Access Compliance Report Public Rights-of-Way (Curb Ramps)

Intersection ID: 20051 Main Street: ARCHDALE_DR Cross Street: BURNLEY_RD Location: S

ADA ID: C02CF6C6D548 Ramp Type: Combination2Diag Initial Pass/Fail: Fail Overall Compliance: No Severity Score: 0

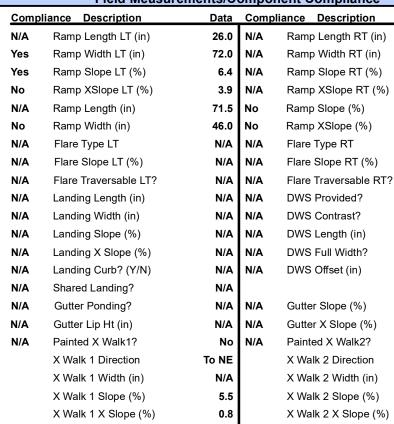
Not Found, R304.5.1, R304.2.2, R304.5.3

Remove & Replace Curb Ramp With Two New Directional Ramps or Equivalent.
